## **HOLLON PLACE II SUBDIVISION**

APPLICATION NUMBER 21 DATE May 6, 2004

REQUEST Subdivision

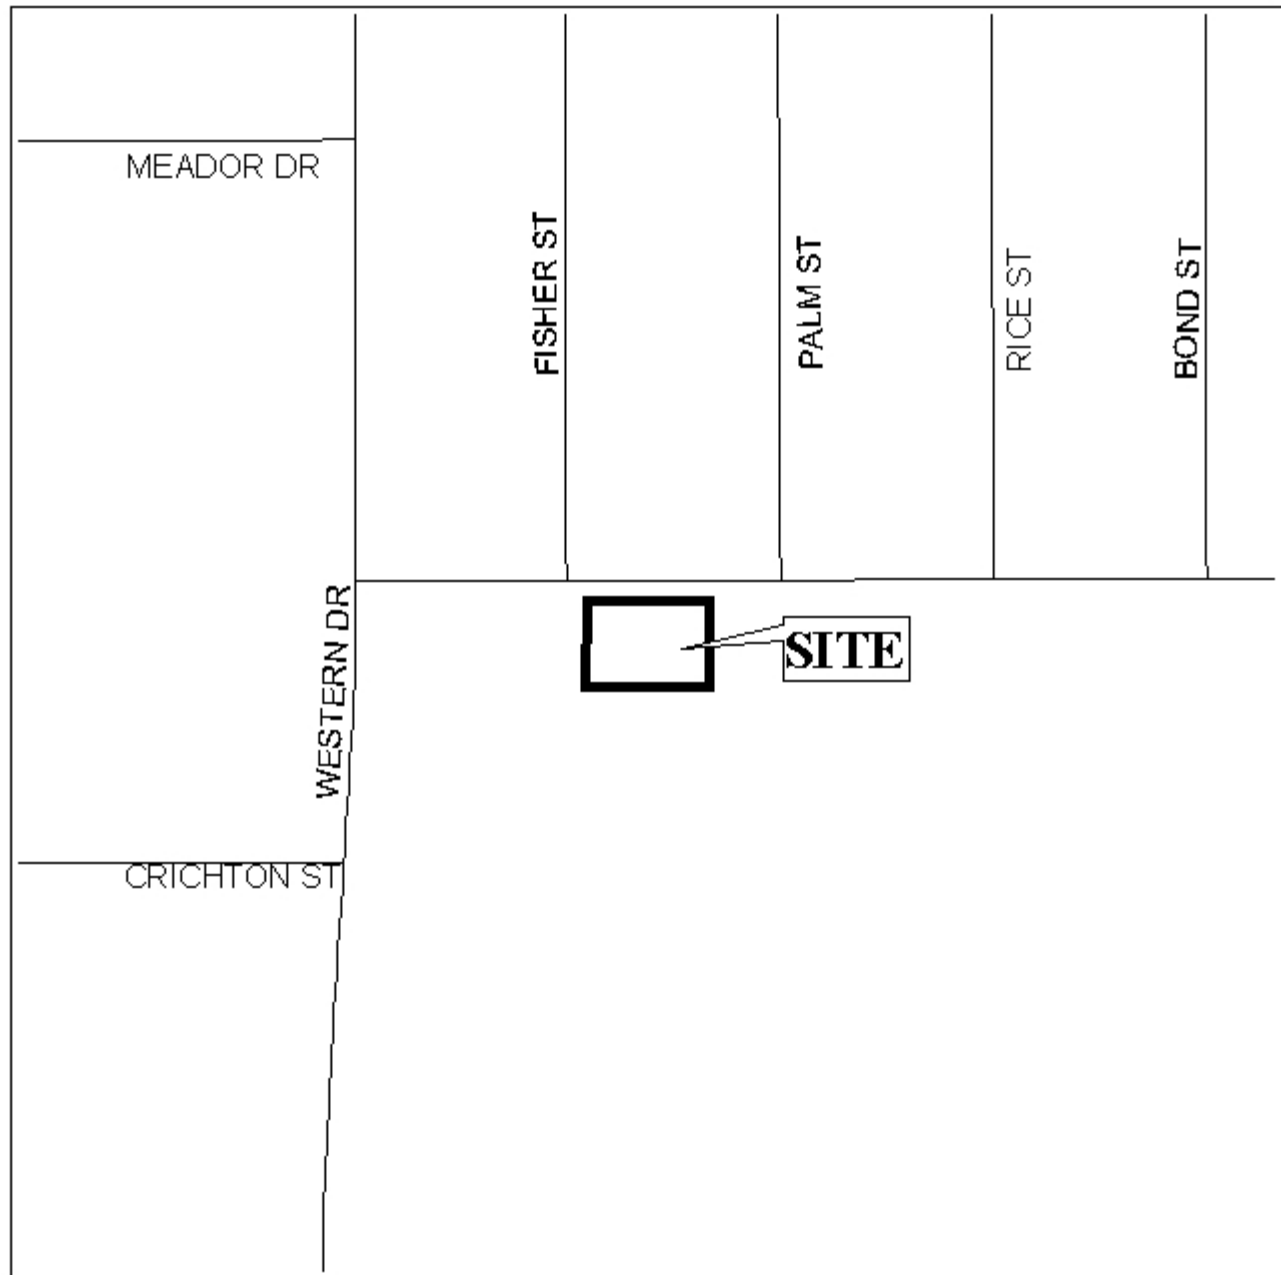
The plat illustrates the proposed 1 lot, 0.5 ± acre subdivision which is located at the Southeast corner of Cotton Street and Fisher Street (unopened right-of-way) and is in City Council District 1. The subdivision is served by public water and sanitary sewer.

The portion of Fisher Street adjoining the site is an unopened right-of-way; therefore, a note should be placed on the final plat stating that the site is denied direct access to Fisher Street.

With the site being a corner lot, the dedication of a 25' radius should be required.

The plat meets the minimum requirements of the Subdivision Regulations and is recommended for Tentative Approval subject to the following conditions: 1) the placement of a note on the final plat stating that the site is denied direct access to Fisher Street; and 2) the dedication of a 25' radius at the intersection of Cotton and Fisher Streets.
